2 Type of change

Product Change Notification					PCN OGN 2nd Production Site		
owner	creation date	release date	released by	change order	rev	page	D10-070-757
zeierjo	18.01.2023	20.01.2023	schulejo	2025354	A	1 of 2

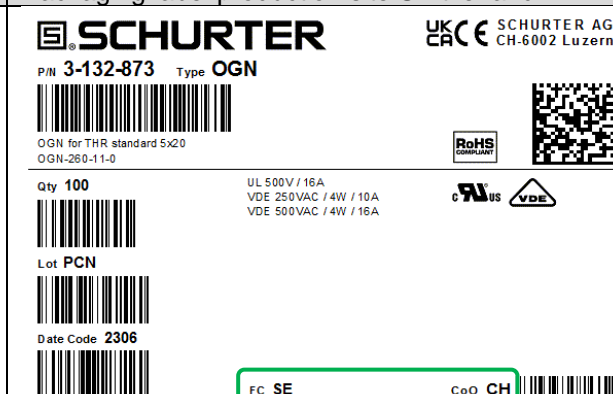
Packaging label production site Czech Republic	Packaging label production site Switzerland
 <p>SCHURTER UKRAINE SCHURTER AG CH-6002 Luzern P/N 3-132-873 Type OGN OGN for THR standard 5x20 OGN-260-11-0 Qty 100 UL 500V / 16A VDE 250VAC / 4W / 10A VDE 500VAC / 4W / 16A Lot PCN Date Code 2306 FC ST CoO CZ</p>	 <p>SCHURTER UKRAINE SCHURTER AG CH-6002 Luzern P/N 3-132-873 Type OGN OGN for THR standard 5x20 OGN-260-11-0 Qty 100 UL 500V / 16A VDE 250VAC / 4W / 10A VDE 500VAC / 4W / 16A Lot PCN Date Code 2306 FC SE CoO CH</p>

- Country of origin (CZ or CH) and factory code (ST or SE) change, depending on the manufacturing site.
